**ITEM 8. DEVELOPMENT APPLICATION: 18-30A MARTIN PLACE -  
ALSO KNOWN AS 20 MARTIN PLACE SYDNEY****FILE NO: D/2012/973****DEVELOPMENT APPLICATION NO: D/2012/973****SUMMARY****Date of Submission:** 29 June 2012 (amended plans received 11 October 2012).**Applicant:** Charter Hall Holdings Pty. Ltd.**Land Owner:** Horizon MP Management Pty. Ltd.**Architect:** James Carpenter Design Associates and Crone Partners.

**Proposal Summary:** The application seeks approval for the refurbishment of an existing building including the relocation of the building's core to the northern elevation and excavation to allow the extension of the existing basement 2 level to the south and provision of a basement ramp from basement 1 to basement 2. A new facade system is proposed with the provision of retail spaces fronting Martin Place, Pitt Street and Hosking Place. The proposal will include 24 tenant car parking spaces, 6 loading/service spaces, 3 motor cycle parking spaces and 113 bicycle spaces. The height of the development will remain at a maximum of 85 metres with an increase in floor space ratio from 11.3:1 to 12.5:1 in accordance with the maximum floor space ratio controls set out in the Sydney

Figure 9 - Proposed massing section (additional 'northern' mass highlighted in yellow)

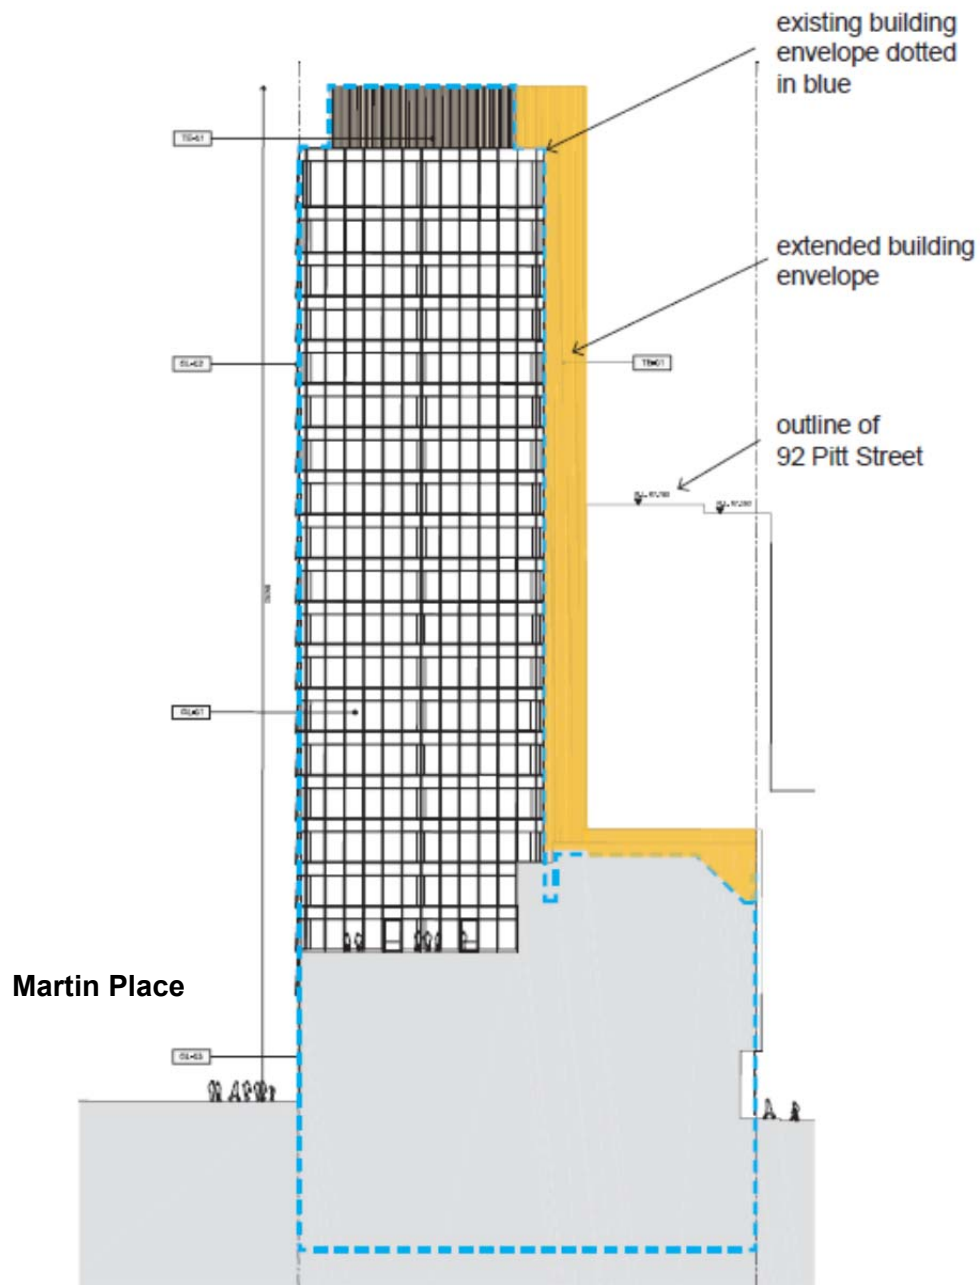
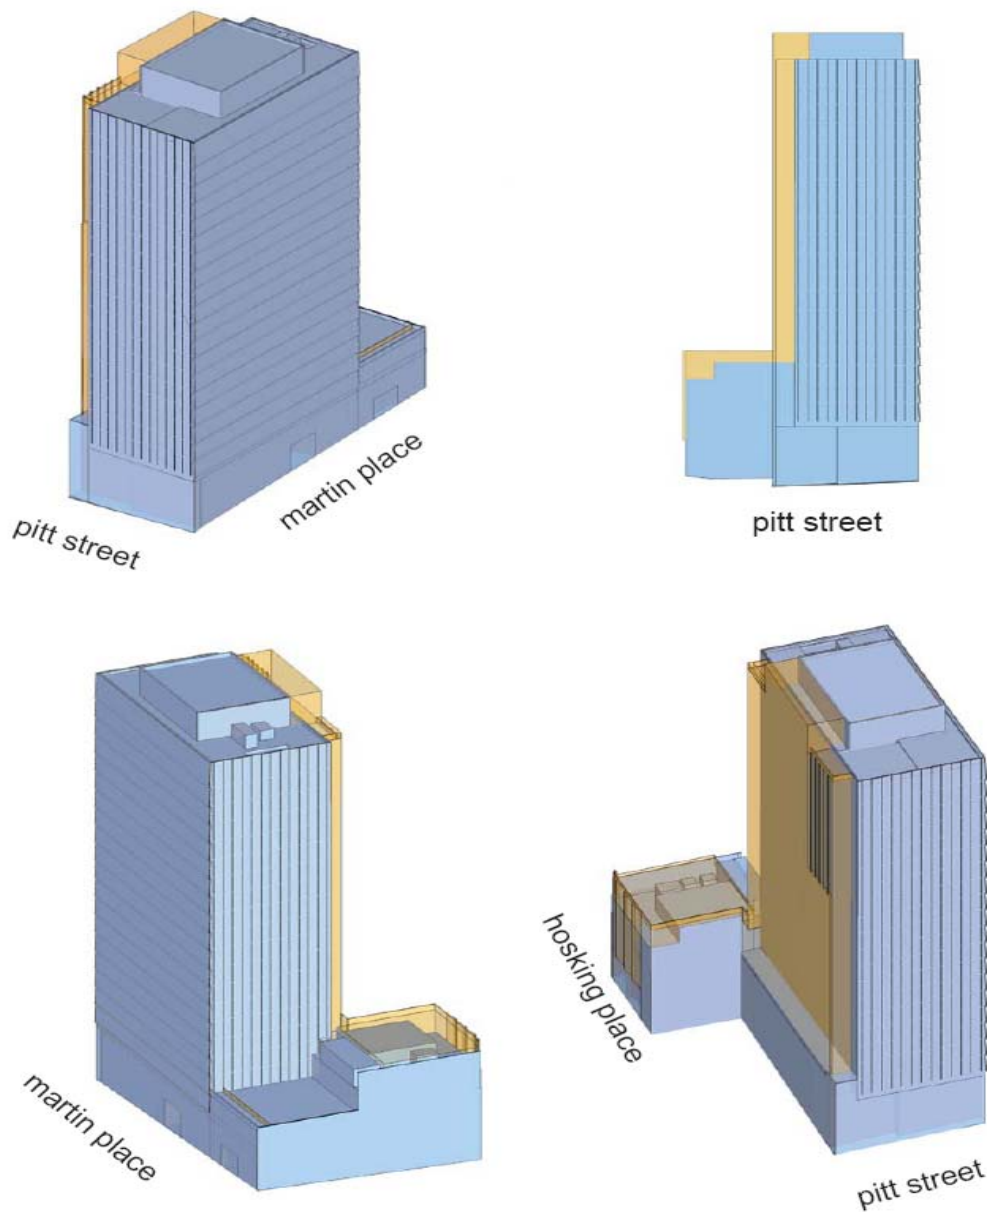
- (f) provision of 24 tenant car parking, loading/servicing, 113 bicycle and 3 motorcycle parking in the existing basement;
  - (g) landscaping works via a green terrace/breakout space and landscaped roof on the eastern podium plant room, and
  - (h) extension/augmentation of physical infrastructure/utilities as required including upgrade of the existing substation in the basement; and
  - (i) increase in the tower floor plate by approximately 150sqm above level 4.
11. The proposed development results in a maximum FSR of 12.5:1. The additional floor space is a result of the internal building reconfiguration and extension of the overall building mass on the northern elevation.
12. Diagrams showing the proposed increase in built form provided below:
